13-15 & 17 Oxford Street and 2 Verona Street, Paddington

Submissions Report

Figure 2 Comparison of Building Footprint

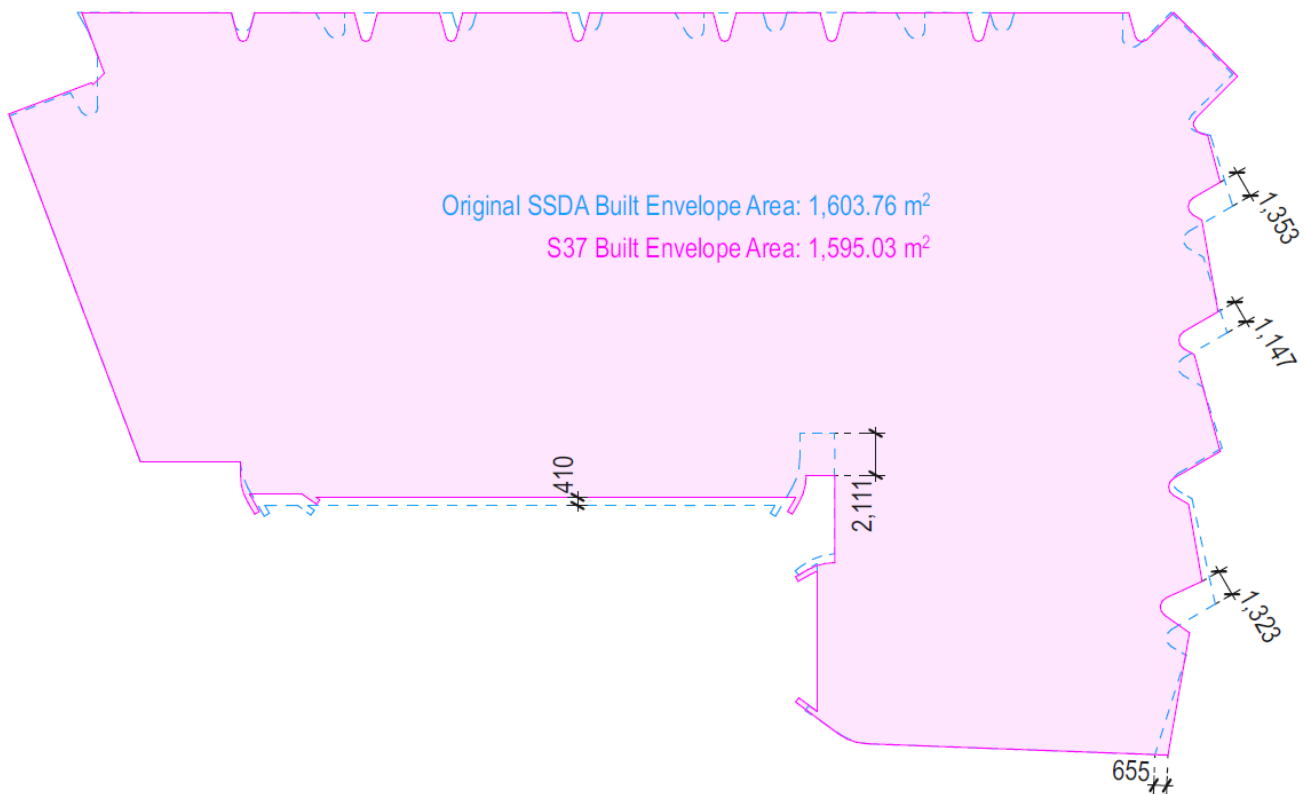
- The only minor adjustment to the envelope is a 410mm setback to the building line (reduction) relative to the exhibited scheme – refer to the figure below. Volumetrically, the refined building envelope is 0.29m³ less than the exhibited scheme.

Figure 7 Exhibited Section

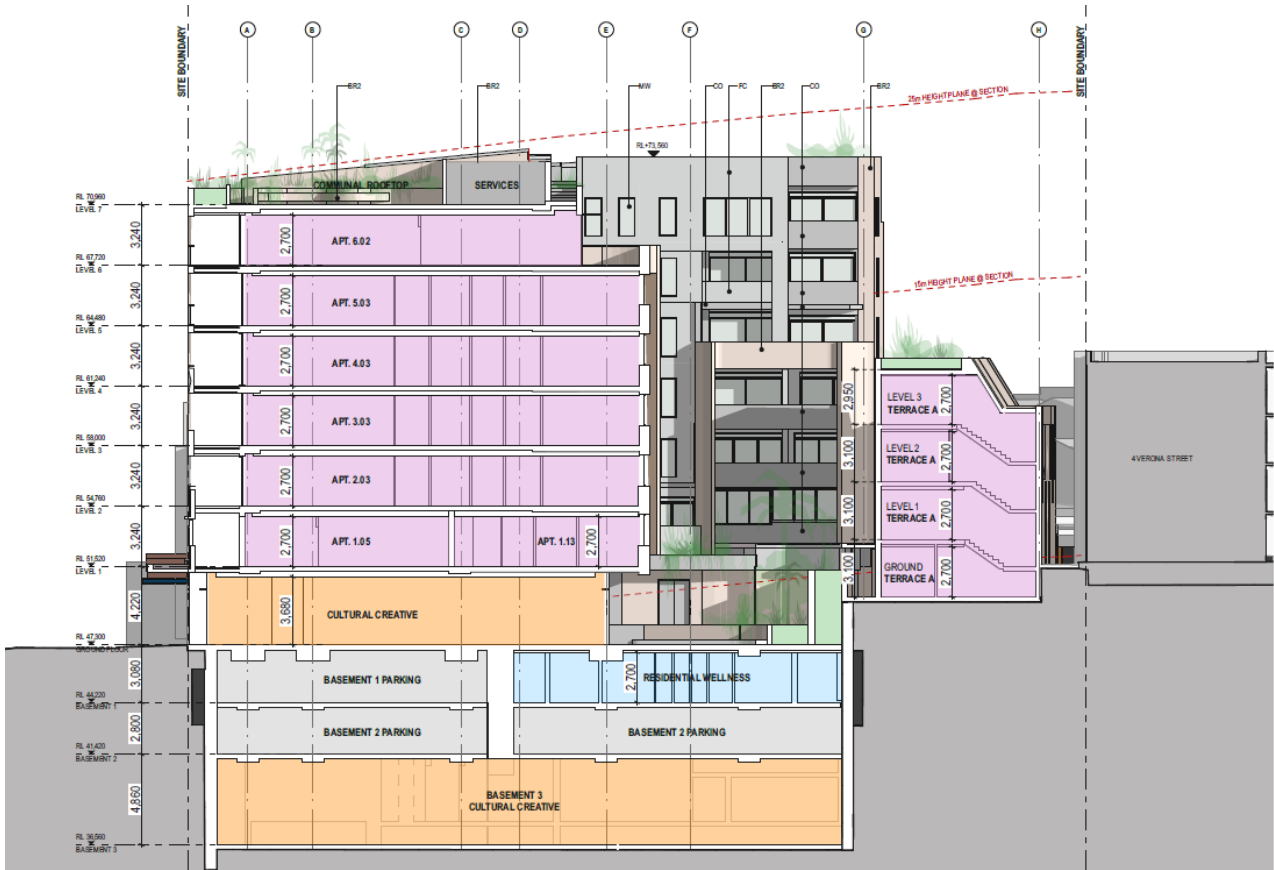
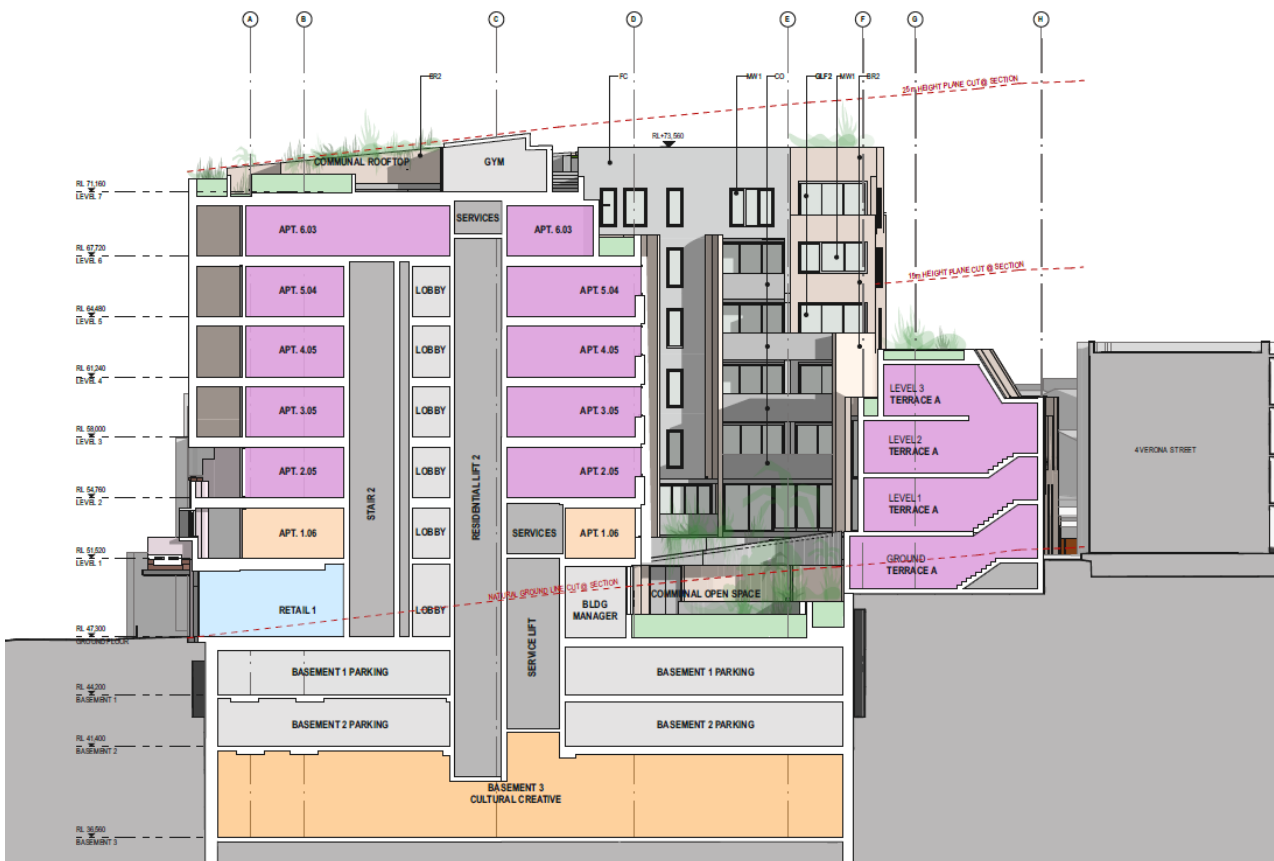
Since the public exhibition of the EIS, the Applicant has refined the proposal to address the matters raised in submissions. The proposed refinements, which represent significant improvements and reduce the environmental impacts of the scheme, include:

Figure 10 Revised Civil Design

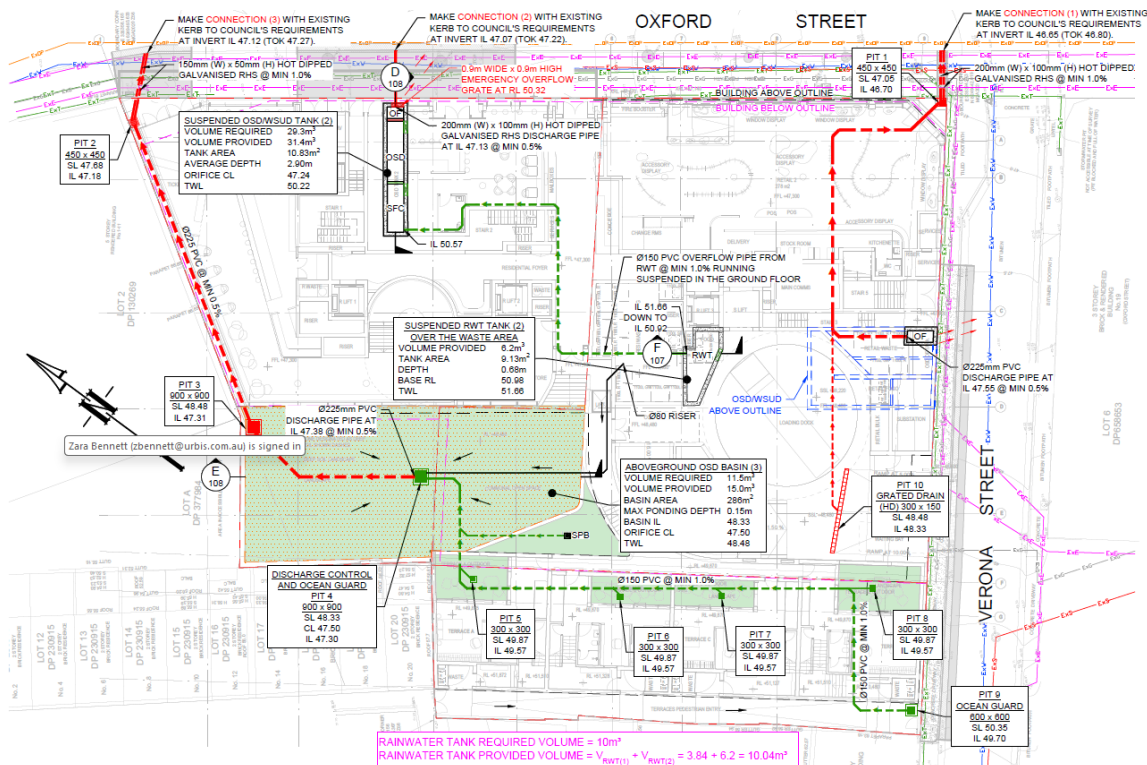
Summary of Issue Raised	Response
<p>A revised design must consider alternative solutions, such as:</p> <ul style="list-style-type: none"> • Connecting to a fully underground drainage system further downstream, or • Providing additional detention to limit discharge to the kerb to a maximum of 25 L/s. <p>If the revised design proposes a kerb outlet with a flow rate below 25 L/s, the discharge should be directed to the Oxford Street kerb, bypassing the existing pit in the laneway entirely. A development control pit may be located closer to the discharge point, within the property but outside the proposed enclosed retail area. The design must demonstrate:</p> <ul style="list-style-type: none"> • Gravity discharge from the OSD to the new discharge point; • A controlled/piped emergency overflow; • Permissible site discharge to kerb will be limited to 25 L/s for storms up to and including the 20yr ARI; • Dry-weather flow is not permitted through kerb outlets and these discharge systems are subject to timed pumping between the hours of midnight and 4am, <p>A longitudinal section must include:</p> <ul style="list-style-type: none"> • Existing surface levels • Proposed invert levels and distances • Pipe size and slope (%) • Hydraulic Grade Line (HGL) for the 5% and 1% AEP, including the critical storm event <p>Additionally, updated DRAINS modelling must be provided to reflect the refined design and incorporate a climate change factor in accordance with Bureau of Meteorology guidance.</p>	<p>This approach mimics the pre-development drainage pattern, which historically included multiple discharge points along the street frontage, thereby ensuring consistency with established site hydrology. The existing shallow pit within the laneway is no longer utilised, and all flows are directed to Oxford Street kerb outlets, fully addressing the concerns regarding insufficient pit depth and pipe cover.</p> <p>The DRAINS model has been fully updated to reflect this revised arrangement, including:</p> <ul style="list-style-type: none"> • Revised OSD configurations. • Three kerb outlet discharge points. • Climate change allowance per Bureau of Meteorology guidance. <p>Additionally:</p> <ul style="list-style-type: none"> • Stormwater flow rates have been calculated to reflect any climatic change impacts that could, in the future, further increase demand on the relevant infrastructure. • Longitudinal sections have been provided, showing existing surface levels, proposed invert levels, pipe sizes, slopes and Hydraulic Grade Lines (HGL) for the 5% and 1% AEP storms, including the critical storm event; and • A dry weather flow note confirms that kerb outlets will not convey dryweather flow and are subject to timed pumping between midnight and 4am. <p>This revised design fully addresses the RFI requirements and demonstrates compliance with the City's stormwater management criteria.</p>

- The total OSD storage volume provided exceeds Sydney Water’s required volume.
- A climate change factor has been incorporated in the DRAINS model in accordance with Bureau of Meteorology guidance.

- Longitudinal sections are provided, showing existing surface levels, proposed invert levels, pipe sizes, slopes, and Hydraulic Grade Lines (HGL) for the 5% and 1% AEP storms.

- The kerb outlets will not convey dry-weather flow and are subject to timed pumping between midnight and 4 am.
